**CITY OF NAPOLEON
BUILDING CONSTRUCTION PERMIT
(1, 2 or 3 Family Dwelling)**

Permit No. 321-75
 Issued 8/30/75
 By Thomas W. Brown
 Building Inspector

Re: 24' x 24' Addition to Existing Garage
Located in "A" Zone - Bldg. Permit No. 321-75

TO Julian Grant
212 FIFTH ST.
Napoleon, Ohio
Addendum To Plan Approval

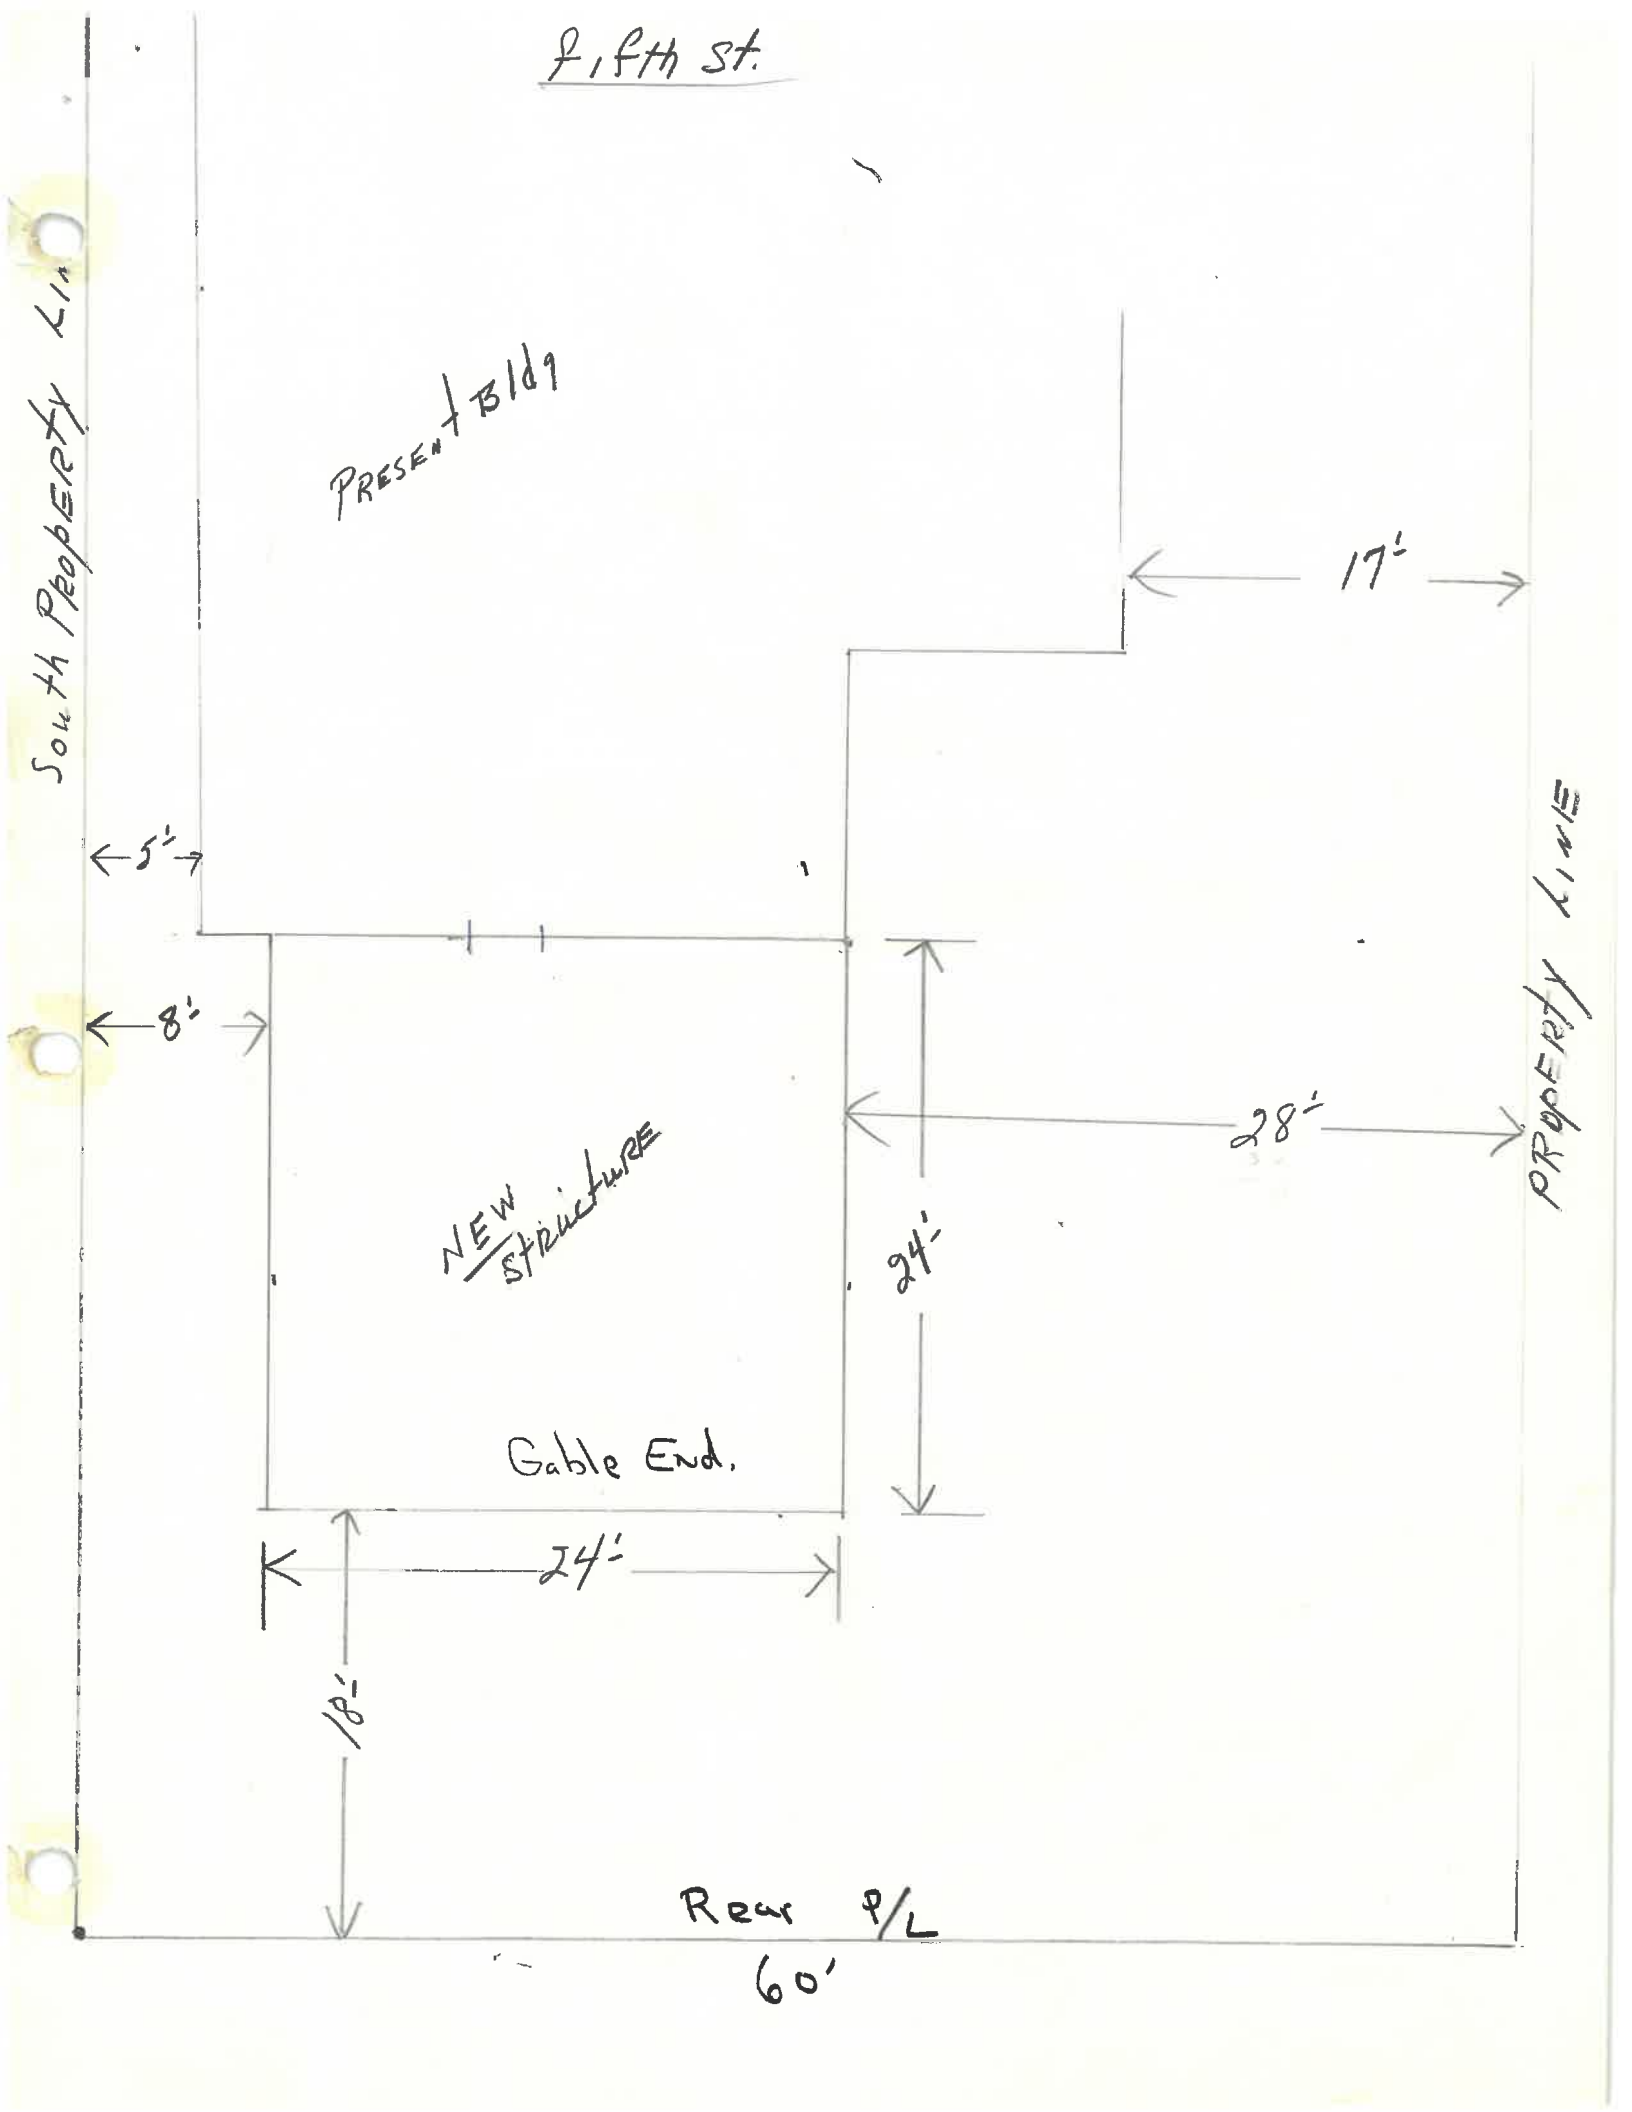
- During plan review and requires compliance with the City's adopted codes:
- 1) Provide 1/2" by 8" long anchor bolts every 8' o/c.
Sec. R303, & Fig. A3 of BOCA.

- 2) Wire mesh or contraction joints, 4" base course, and vapor barrier for concrete slab, Sec. R603 - Fig A3.4
 - 3) IF Alum. or steel siding must be grounded & bonded, in a approved manner, BB-43-15.01 of OBC.

- 4) Wall bracing, 1"x4" let-in or an approved sheathing
Sec. R-503
 - 5) Because of span of ceiling joist (24') must use 2"x8" 12" o/c. Table No. 7-B
 - 6) Provide proper thermal insulation in ceiling & walls, Sec. 876.1 BOCA 75'

- 7) Provide proper ventilation of attic area, Sec. R-705
 - 8) Provide min. size of 22"x30" access opening to attic area. Sec. R-706 (2' min. head clearance)

- 9) Wall between garage and new addition shall have 45 minute fire rating, (1/2" reg. gyp both sides). Door into garage shall be 1 3/4" solid core wood or equivalent.
